Technical Bulletin

HAMMOND ORGAN

TO ALL MAINTENANCE ENGINEERS - CHANGES

26 E-100 Series
E-200 Series
E-300 Series

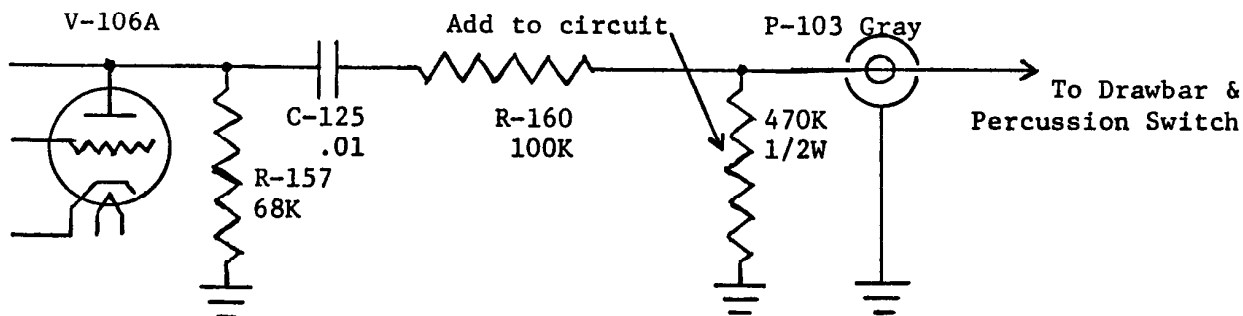
To eliminate Percussion pop when "Drawbars and Percussion" tab is depressed. Add A470K 1/2 watt resistor in Percussion amp. chassis as indicated in drawing below.
